**Pacific Gas and
Electric Company®**

Reference: PG&E Gateway Generating Station (00-AFC-01C)

Subject: PETITION FOR INSIGNIFICANT PROJECT CHANGE TO PLANT FACILITY

**PETITION FOR INSIGNIFICANT PROJECT CHANGES
AT
GATEWAY GENERATING STATION**

ATTACHMENT A
MARKED-UP FACILITY LAYOUT

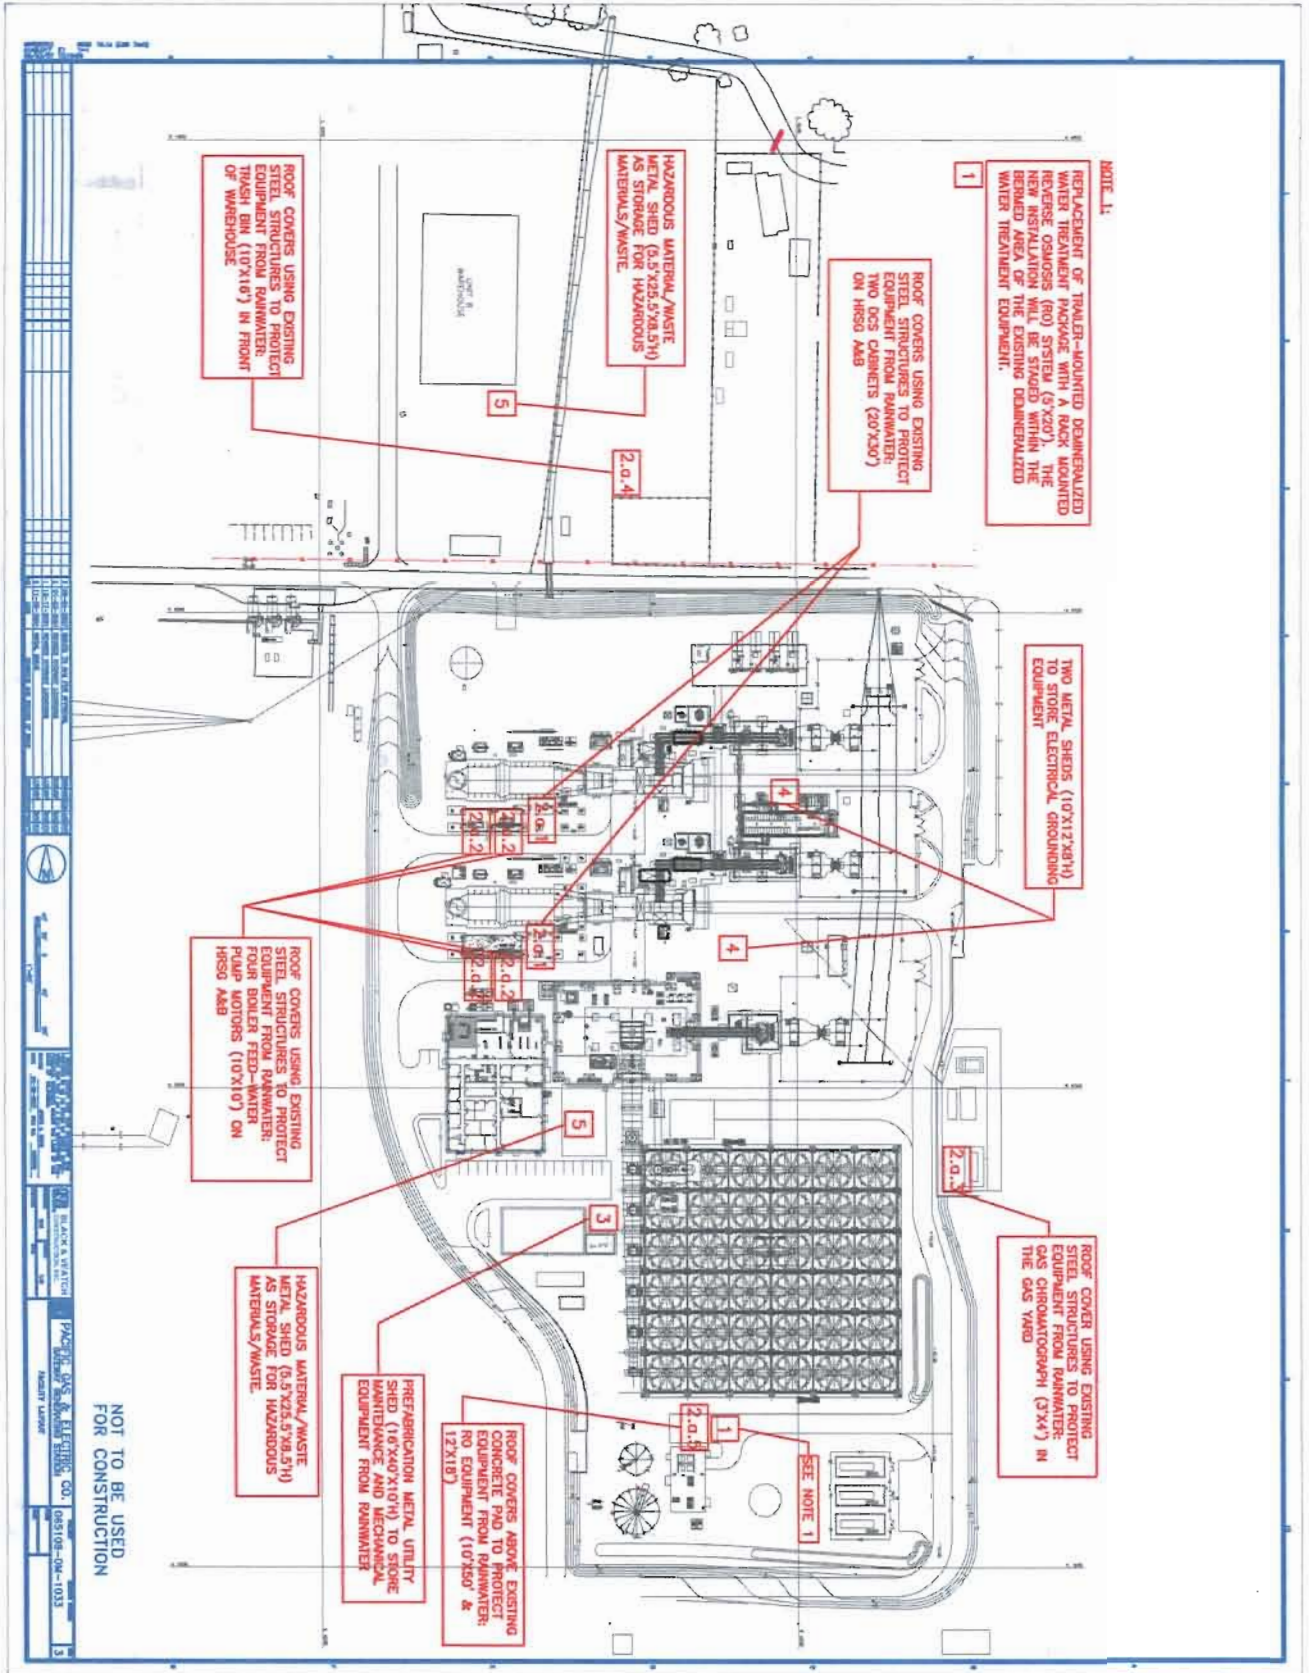
- 1. Two (2) DCS Cabinets (20' x 30') one each at HRSG-A and HRSG-B at elevation 35 feet above grade level. The roof cover will be attached to existing structural frames. (See Attachment A: Marked-up Facility Layout, labeled 2.a.1, for site location.)

- 2. Four (4) Boiler Feed-water Pumps (10' x 10') two each at HRSG-A and HRSG-B on grade level. The roof cover will be attached to existing structural frames. (See Attachment A: Marked-up Facility Layout, labeled 2.a.2, for site location.)

- 3. Gas Chromatograph (3' x 4') in the gas yard on grade level. The cover will be attached to existing structural frames. (See Attachment A: Marked-up Facility Layout, labeled 2.a.3, for site location.)

- 4. Trash Bins (10' x 16') on ground level. There will be additional six columns (10' H) to support this roof cover. (See Attachment A: Marked-up Facility Layout, labeled 2.a.4, for site location.)

support the roof cover. (See Attachment A: Marked-up Facility Layout, labeled 2.a.5, for site location.)

- a. **Description of Modification:** This modification proposes to install a pre-fabricated metal utility shed with dimension: 16' x 40' x 10' H, to store maintenance and mechanical equipment. Concrete flooring will be provided for this installation. (See Attachment A: Marked-up Facility Layout, labeled 3, for location of the proposed modification.) (See Attachment D: Photo of Typical Pre-fabricated Metal Shed.)

- a. **Description of Modification:** This modification proposes to install two (2) metal "Tuff" sheds with dimension: 10' x 12' x 8'H, on grade level to store electrical grounding equipment. (See Attachment A: Marked-up Facility Layout, labeled 4, for location of the proposed modification.)

- a. **Description of Modification:** This modification proposes to install two (2) portable metal sheds with dimension: 5.5' x 25.5' x 8.5'H, on grade level to store hazardous materials/waste. (See Attachment A: Marked-up Facility Layout, labeled 5, for location of the proposed modification.) The shed is equipped with secondary containment, fire suppression equipment, and eye-wash station. (See Attachment E: Hazardous Materials/ Waste Shed Specification). The hazardous material/waste storage is a component part of the Waste Management Plan for the facility. The plan was submitted to CEC to comply with Condition of Certification WASTE-2 on December 3, 2008.

NOTE 1:
 REPLACEMENT OF TRAILER-MOUNTED DEMINERALIZED WATER TREATMENT PACKAGE WITH A RACK MOUNTED REVERSE OSMOSIS (RO) SYSTEM (9'X20'). THE NEW INSTALLATION WILL BE STAGED WITHIN THE REMOVED AREA OF THE EXISTING DEMINERALIZED WATER TREATMENT EQUIPMENT.

PG&E, GATEWAY GENERATING STATION FLOW DIAGRAM

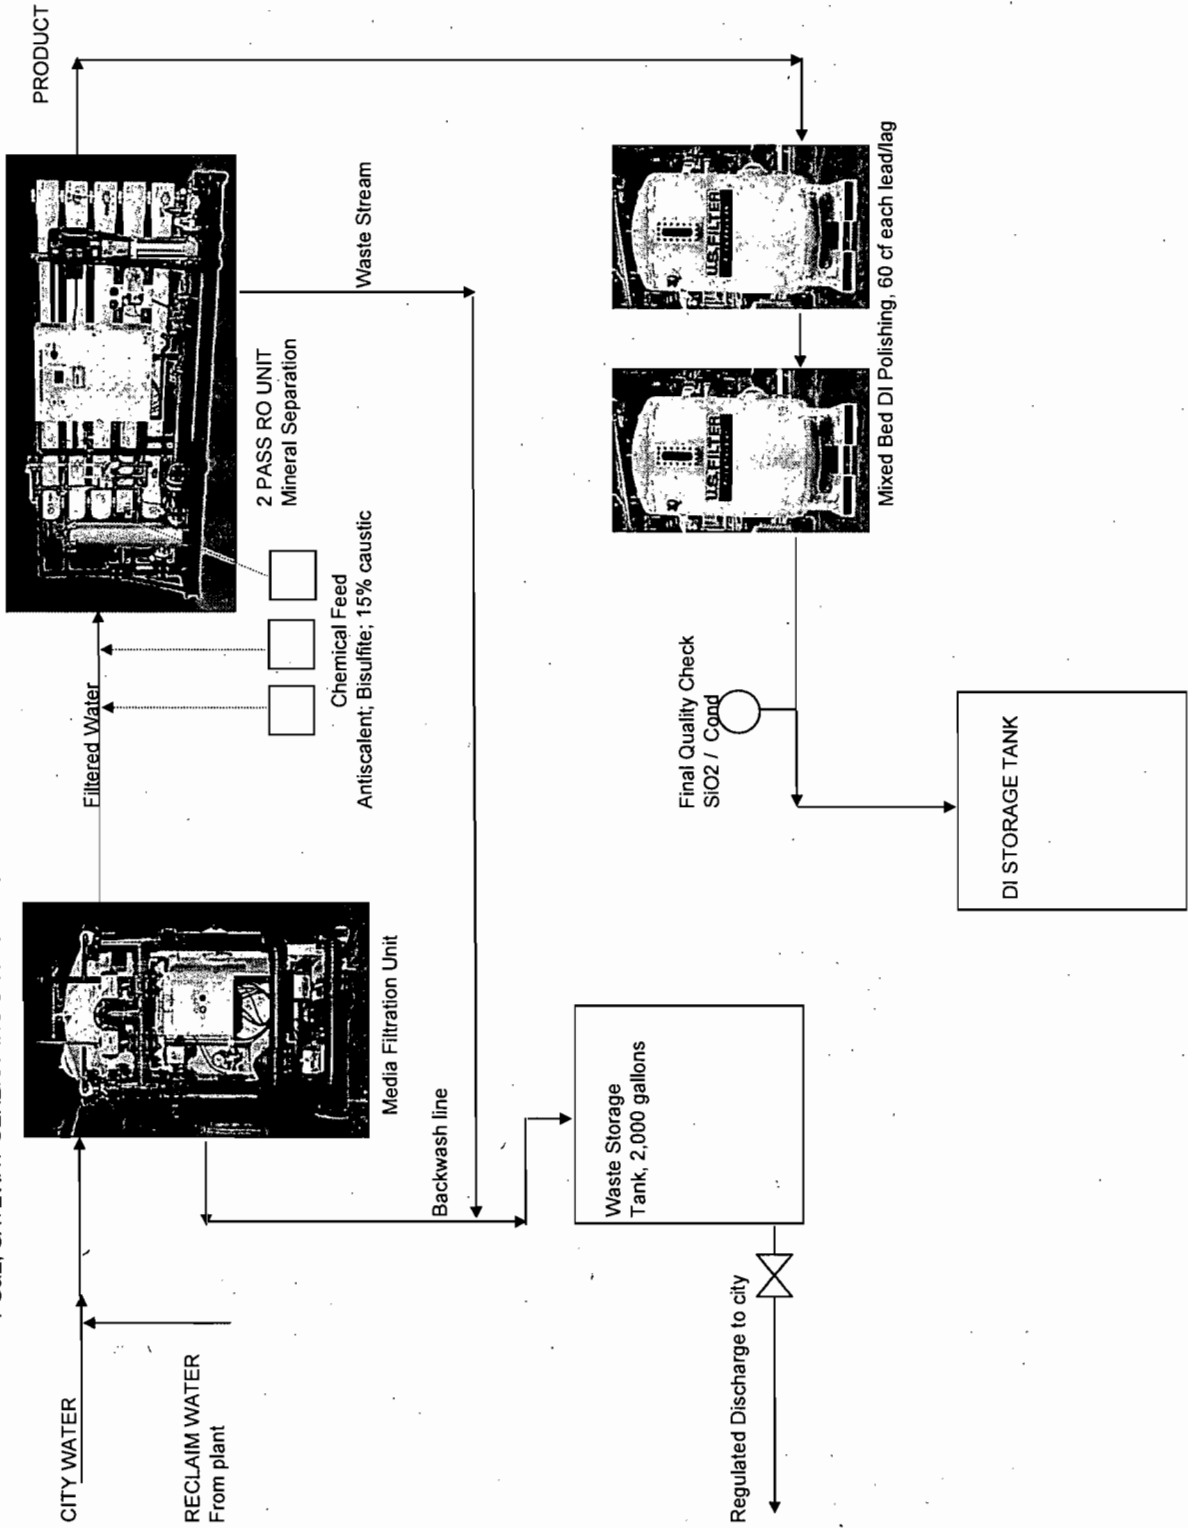
1. Replacement of Trailer-mounted Demineralized Water Treatment Package with Rack-mounted Reverse Osmosis System
 - a. **Description of Modification:** This modification proposes to replace the existing trailer-mounted demineralized water treatment package with rack-mounted reverse osmosis (RO) system that includes a water polisher. The new installation with area dimension of 5' x 20' will be staged within the existing bermed area (28' x 50'). (See Attachment A: Marked-up Facility Layout for location of the proposed modification.) The RO system will utilize less than 50 gallons each at any given time of sodium hydroxide, sodium bi-sulfite, and Vitec 3000 (a proprietary product with mostly sodium hydroxide as a component). Both sodium hydroxide and sodium bi-sulfite are listed in HAZ-1 Appendix C Table 8.12-4 of the Commission Decision 900-AFC-1). (See Attachment B: RO System Process Description and Flow Diagram.)

PG and E Gateway Generating Power Plant will be providing City of Antioch, CA city water mixed with water from the plant Reclaim tank for processing by Siemens. Design includes specialized iron media filtration, 2 pass Reverse Osmosis to minimize the DI loading as much as possible (99.9% mineral removal), caustic interstage feed for complete CO₂ removal to protect the anion capacity, and two stage lead/lag Mixed Bed DI Polish. The feed water is detailed in the water analysis shown in Attachment A.
